Response to Council, DIT and ODASA comments - DA 24037925

URPS continues to act for Samaras Construction & Developments (the Applicant). We have been asked to respond to the requests for further information (RFI) issued by the City of Unley (Council) and the Department of Infrastructure and Transport (DIT).

Figure 1 - Certificate of Title

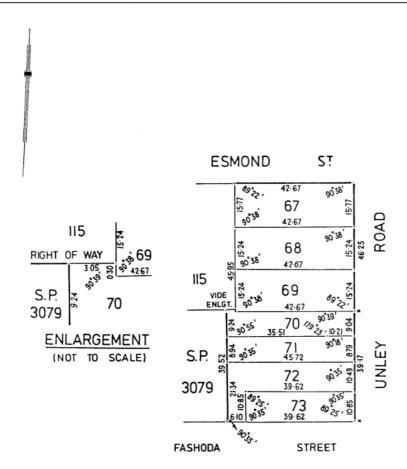
We acknowledge the Council's concerns regarding the proposed vehicular access from Esmond Street via a Right of Way. We would like to provide the following clarifications:

The subject property has a registered Right of Way which extends from Esmond Street in a southerly direction, as confirmed by the Certificate of Title for the subject land and Filed Plan 11716. As shown in **Figure 1-3** below:

Filed Plan 11716 which is referred to within the endorsement of the Easement in the above CT. The Filed Plan more clearly shows the relationship between Lot 115 and the subject land. It is an "L-shaped" allotment of 4.57 metres in width which adjoins the western boundary of the subject land.

The development site has always included the relevant portion of the Right of Way which is proposed to be upgraded with permeable paving on shown on the SMFA Location Plan submitted at verification (as opposed to the whole of Lot 115 which extends into the adjoining Zone and so there is no need to "include the land as part of the application" at this stage). The original planning report submitted by URPS dated 8 November 2024:
